**SUBJECT:** Victoria Square Boulevard – Project Status Update

**PREPARED BY:** Alberto S. Lim, Sr. Capital Works Engineer, Ext. 2860  
Alain Cachola, Senior Manager, Infrastructure and Capital  
Projects, Ext. 2711

The purpose of this report is to obtain Council approval to award the additional design work to Ainley Group for professional services associated with Victoria Square Boulevard, increase the purchase orders to the various utilities for the relocation of existing facilities, and request additional budget for the design, utility relocation and culvert construction works.

## Attachment B - Victoria Square Boulevard where MUP is retained under revised design

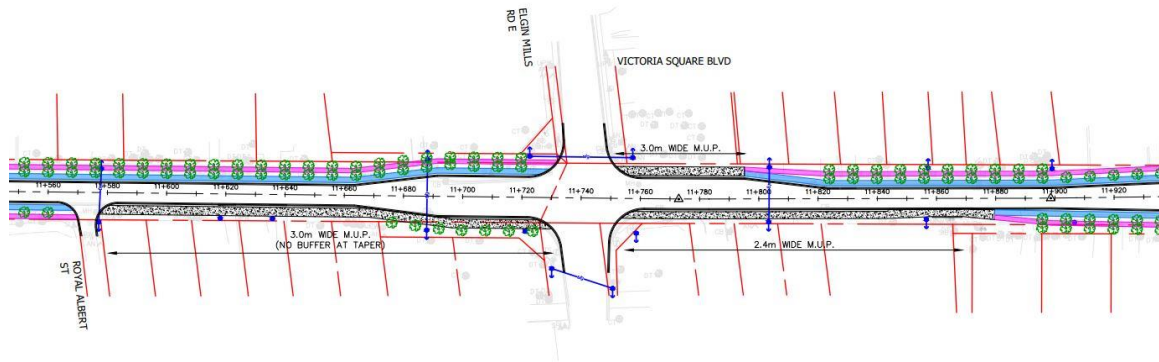
Staff determined that installing a separate sidewalk and cycle track within the boulevards on each sides of the road was feasible for most of the Victoria Square Boulevard. There is a stretch of Victoria Square Boulevard, approximately 300m in length and located north and south of Elgin Mills where continuous separated cycle track and sidewalk facilities could not be achieved due to both right-of-way constraints and existing utility infrastructures. The design will have to revert to a MUP for this 300m stretch which represents approximately 5% of the entire section of Victoria Square Boulevard. The MUP, north of Elgin Mills on the east boulevard, must be at 2.4m in width in order to avoid very costly relocations of existing underground and aboveground Bell infrastructures. The MUP south of Elgin Mills on the east boulevard will be increased to 3.0m in width. This will be determined at the revised design stage. With the proposed MUP on this 300m stretch of Victoria Square Boulevard, there will be no need for any property acquisitions.

Refer to Attachment 'B' for the location of where the MUP design is to be retained.

**Attachment 'C' – Typical Cross-Sections (Original Design vs. Revised Design)**

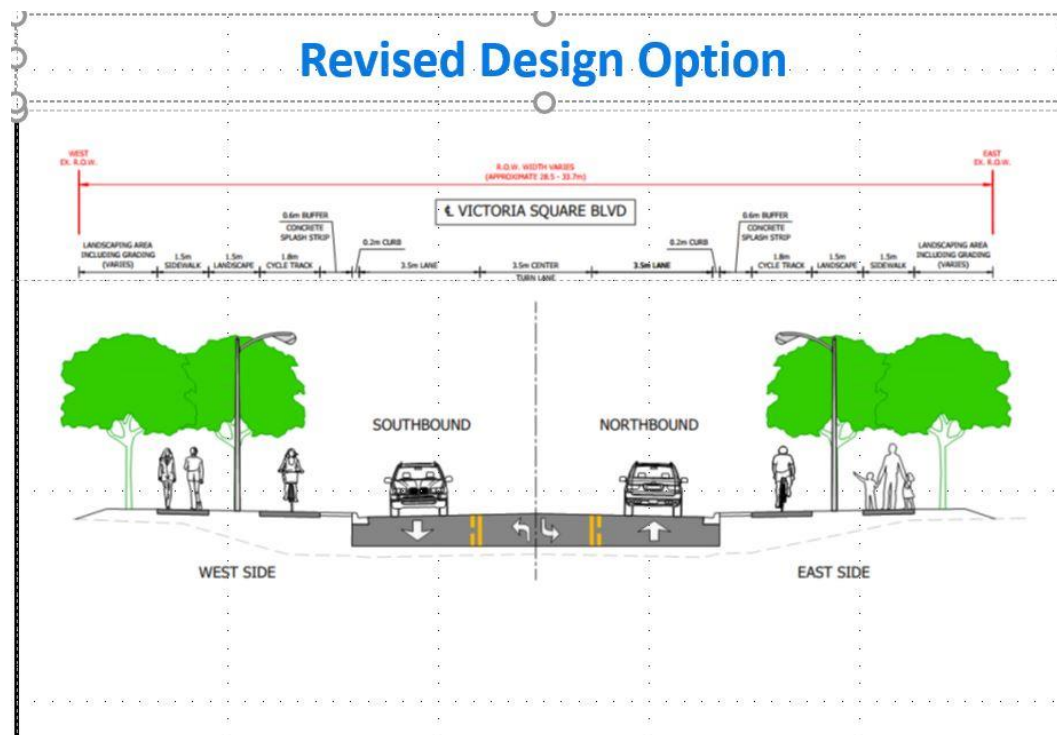
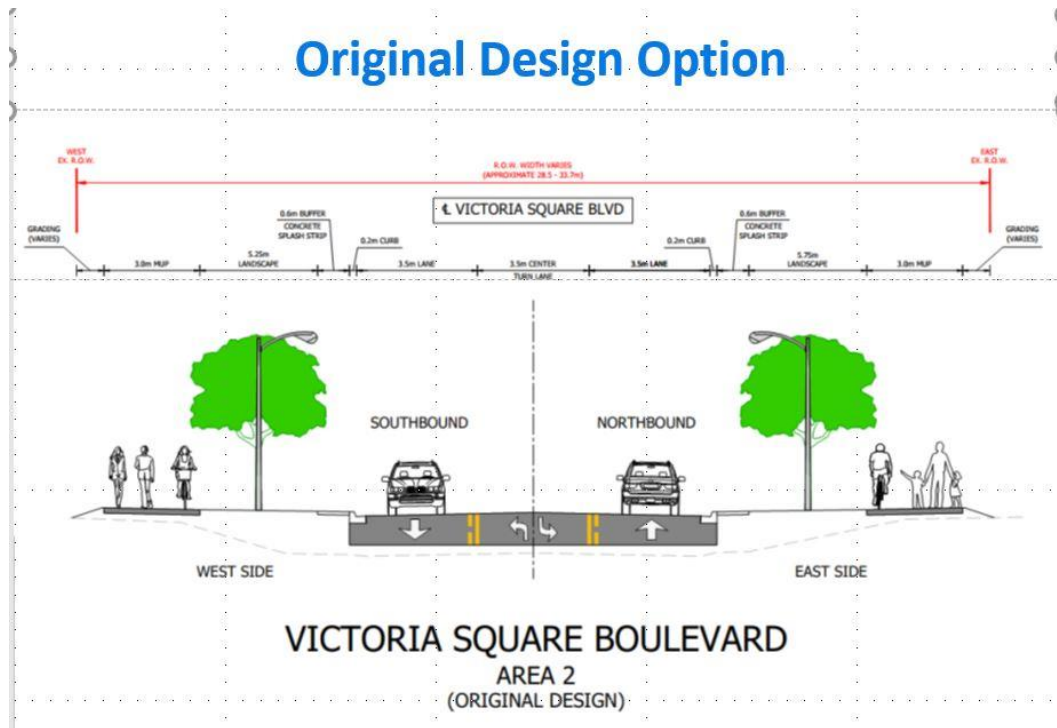
- The 3.0m MUP on both sides of the road can be replaced with separate sidewalk and cycle track facilities where possible
- A transition from separated cycling and sidewalk facilities to 3.0m MUP will still be required at locations where there are right-of-way constraints and significant utility conflicts;
- A double rows of trees, instead of a single row of trees as currently designed, can be installed where possible.
- The streetlighting and landscape features can be revised accordingly based on the new locations of the sidewalk and cycle tracks on the boulevards.
- Consideration for alternate low-level lighting along Victoria Square Boulevard particularly the ceremonial route fronting Cathedraltown development.

Refer to Attachment 'C' for typical cross-sections between the original design and the revised design.

**Attachment 'E' – Revised Construction Phasing Plan**

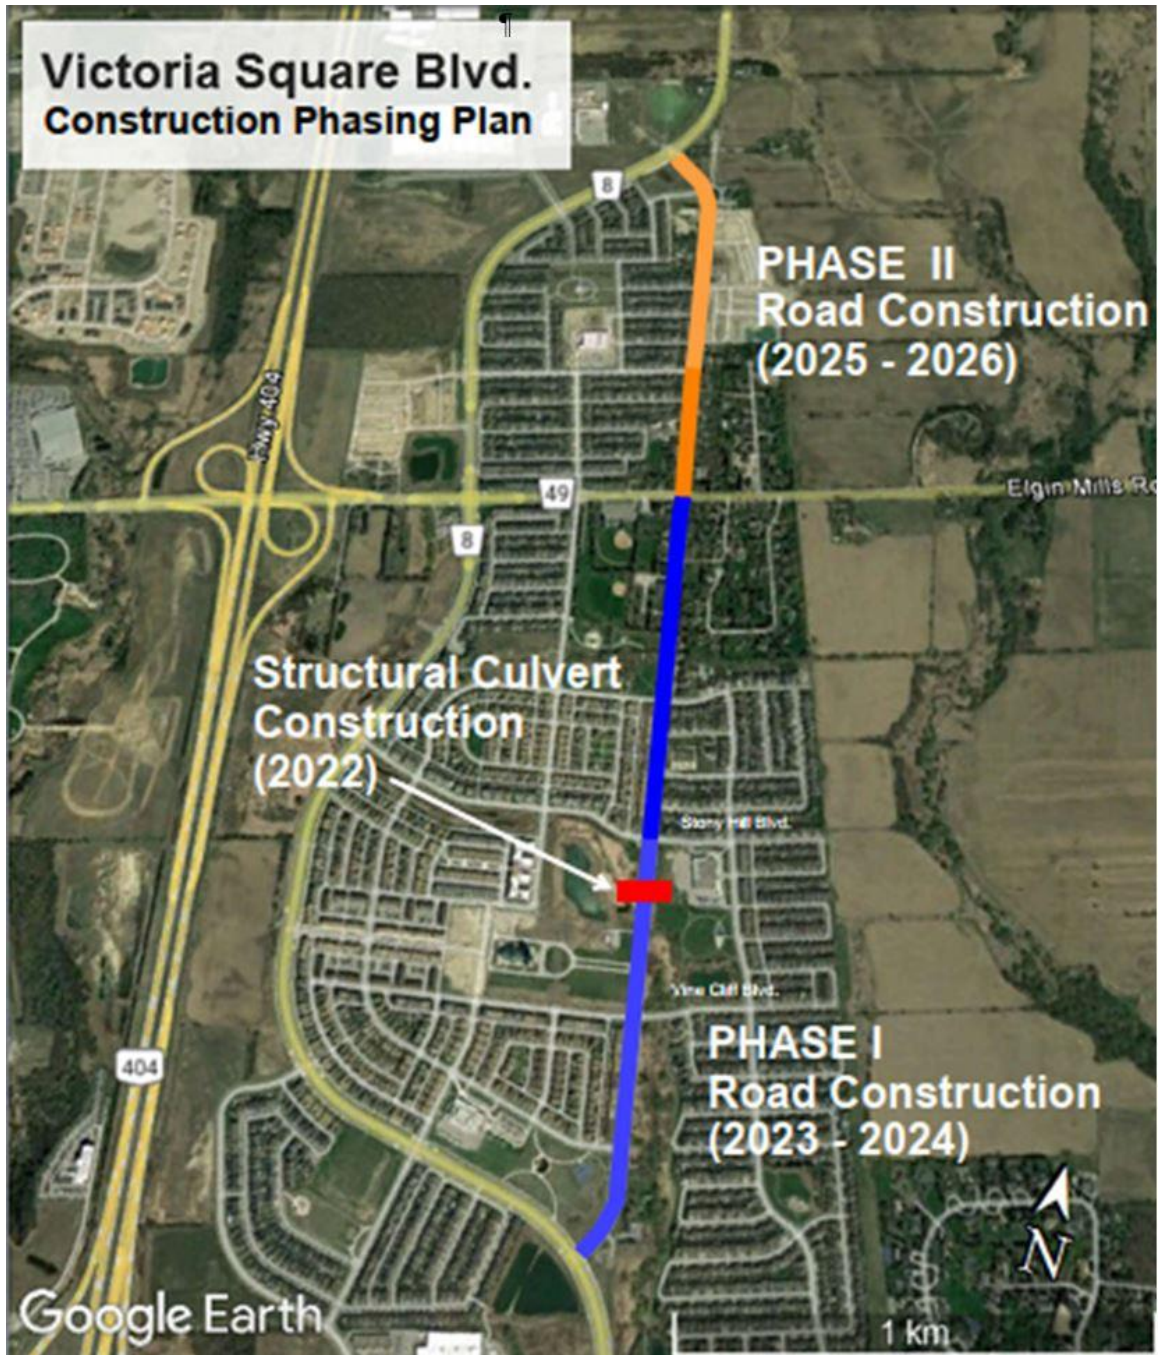
The Elgin Mills EA Study is close to being finalized and filed with the Ministry and will be proceeding into detailed design. The detailed design work for Elgin Mills is scheduled to be issued by spring 2022. Together with further discussions with developer representatives for the FUA, staff has revised the project phasing for reconstruction of VSB with the following phasing of construction and schedules:

- Culvert Construction (2022)
- Phase 1 – Road Construction (including underground infrastructures) – Elgin Mills Road to Woodbine Avenue (South) - (2023 to 2024)
- Phase 2 – Road Construction (including underground infrastructures) - Elgin Mills Road to Woodbine Avenue (North) - (2025 to 2026)

See Attachment 'E' for the revised construction phasing plan.

**Attachment 'F' – Utility Relocation Advancement**

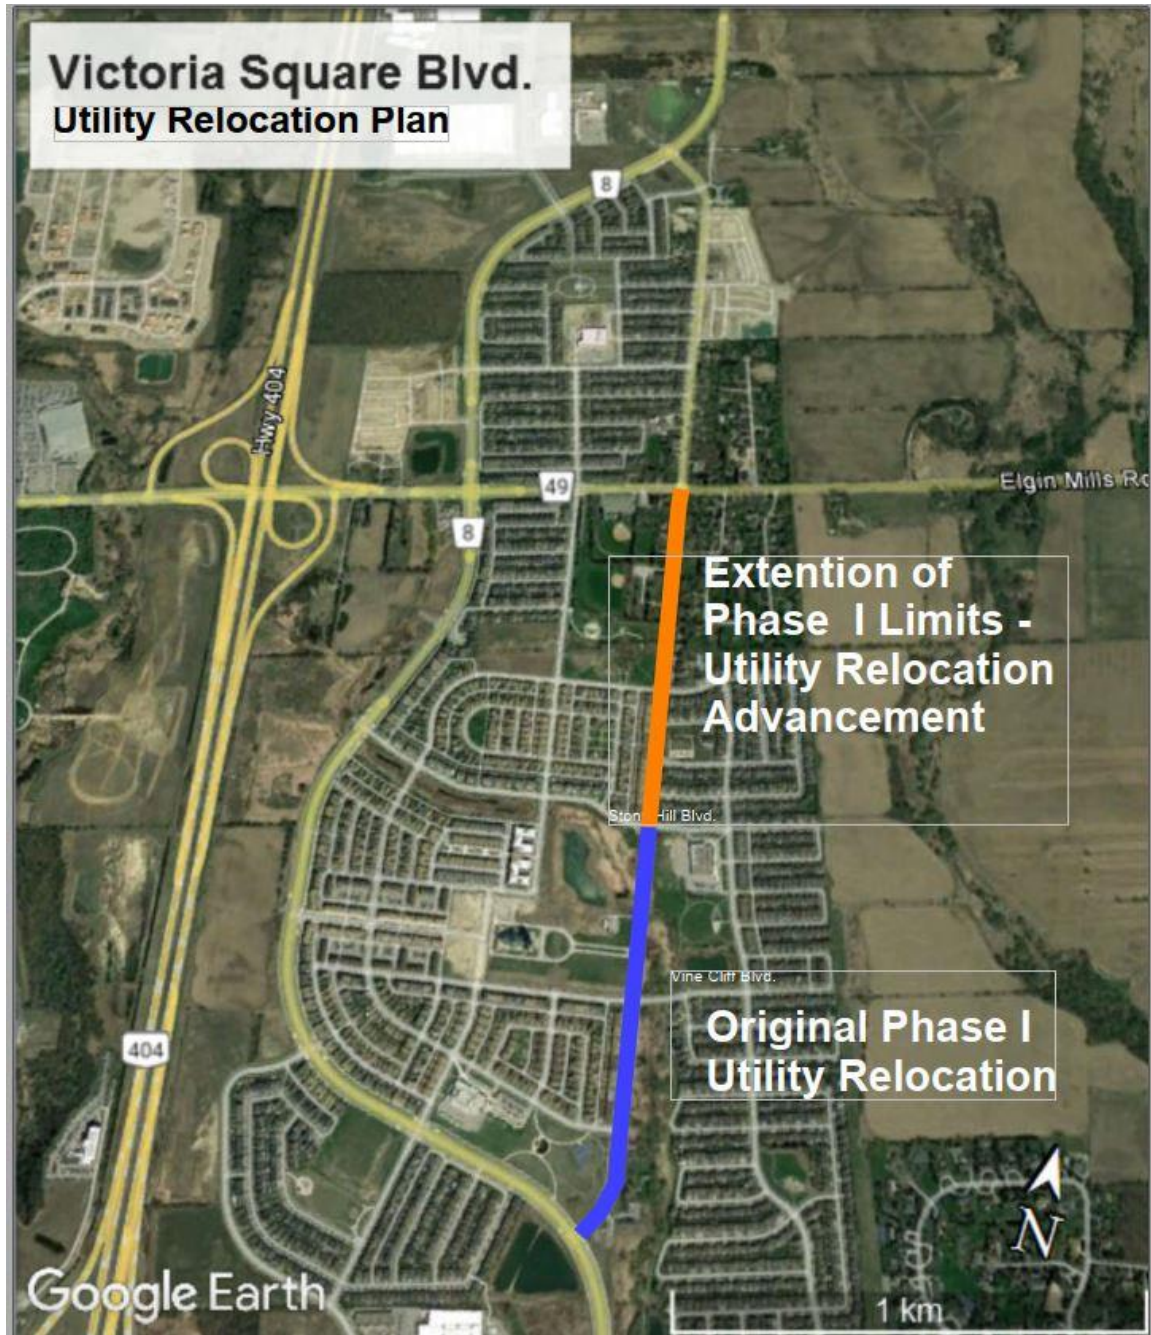
The proposed extension of the original Phase 1 limits from Stony Hill Blvd. to Elgin Mills R. increases the length of utility relocations on Victoria Square Boulevard from 900m to 1750m. Attachment 'F' for the increase in length of utility relocations.
